Form 3160-5 (June 2019)	UNITED STATES DEPARTMENT OF THE INTERIOR BUREAU OF LAND MANAGEMENT	FORM APPROVED OMB No. 1004-0137 Expires: October 31, 2021
SUNDRY NOTICES AND REPORTS ON WELLS <i>Do not use this form for proposals to drill or to re-enter an abandoned well. Use Form 3160-3 (APD) for such proposals.</i>		5. Lease Serial No. NMNM77063
		6. If Indian, Allottee or Tribe Name

Inga 33 Fed Com 1H (FKA 301H) API #: 30-025-51562

EOG respectfully requests an amendment to our approved APD for this well to reflect the following changes:

Revised Wellbore A:

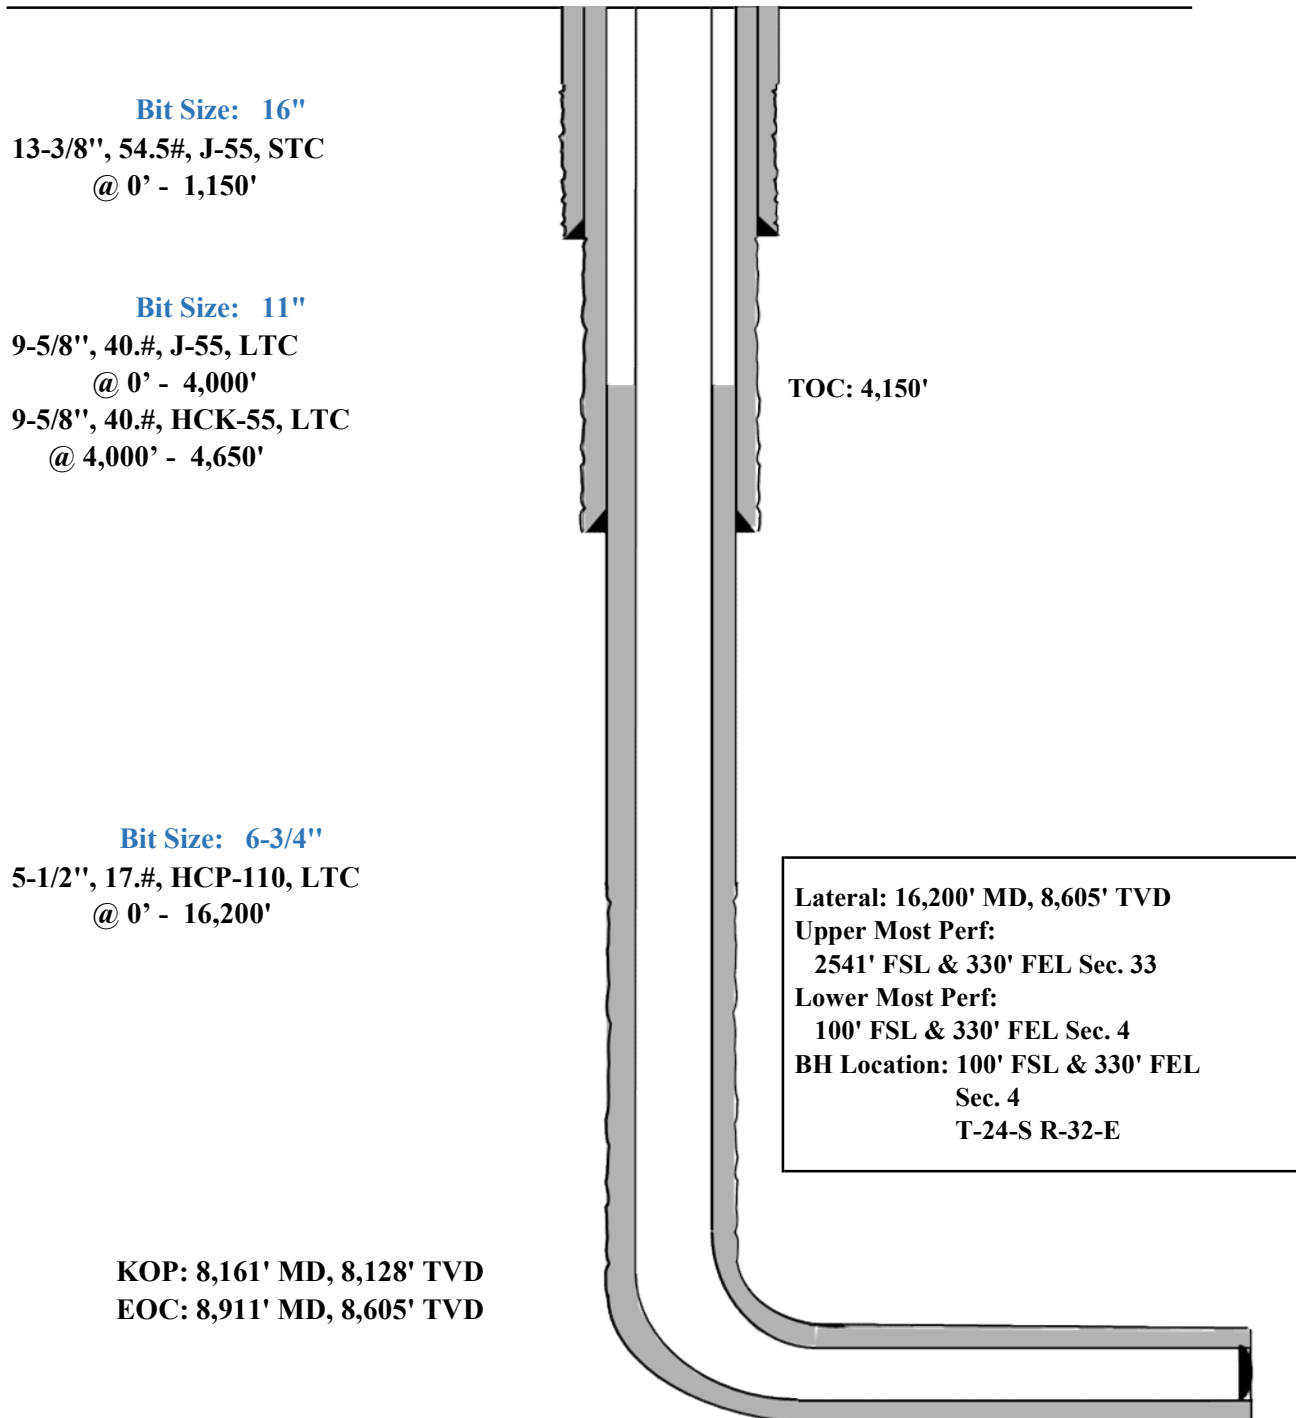
Casing Program A:

Hole Size	Interval MD		Interval TVD		Csg OD	Weight	Grade	Conn
	From (ft)	To (ft)	From (ft)	To (ft)				
16"	0	1,150	0	1,150	13-3/8"	54.5#	J-55	STC
11"	0	4,035	0	4,000	9-5/8"	40#	J-55	LTC
11"	4,035	4,685	4,000	4,650	9-5/8"	40#	HCK-55	LTC
6-3/4"	0	16,200	0	8,605	5-1/2"	17#	HCP-110	LTC

Variance is requested to waive the centralizer requirements for the 9-5/8" casing in the 11" hole size. An expansion additive will be utilized, in the cement slurry, for the entire length of the 11" hole interval to maximize cement bond and zonal isolation.

Variance is also requested to waive any centralizer requirements for the 5-1/2" casing in the 6-3/4" hole size. An expansion additive will be utilized, in the cement slurry, for the entire length of the 6-3/4" hole interval to maximize cement bond and zonal isolation.
